# UMBRA

September 21, 2021

Re: Umbra Lab, Inc., IBFS File No. SAT-LOA-20210616-00080; Call Sign S3095

In response to the International Bureau's letter dated September 2, 2021 (the Letter), Umbra Lab, Inc. (Umbra) provides the following additional information to assist in the review of Umbra's above-referenced application (the Application) requesting authority to construct, deploy, and operate six satellites (the Umbra SAR Constellation). For your convenience, the inquiries in the Letter are reproduced in italics below (without citations).

1. Gain Contour (X Band, Svalbard, 2x2)

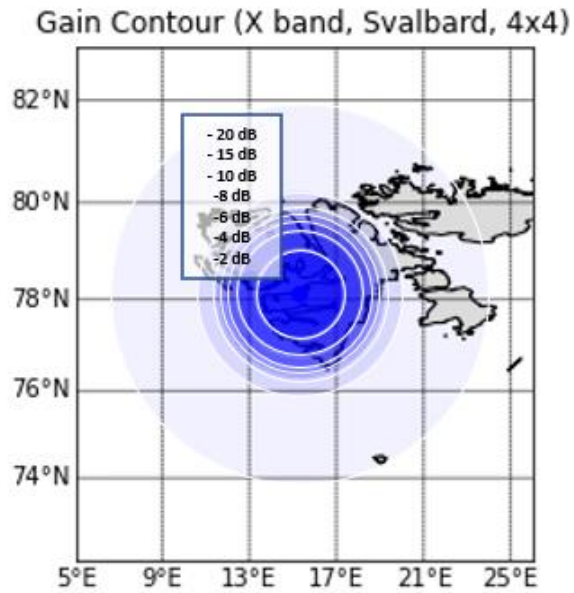
6. *Please resubmit the antenna contour plots provided in the technical attachment in a larger and clearer format.*

Antenna contour plots are attached to this Letter.
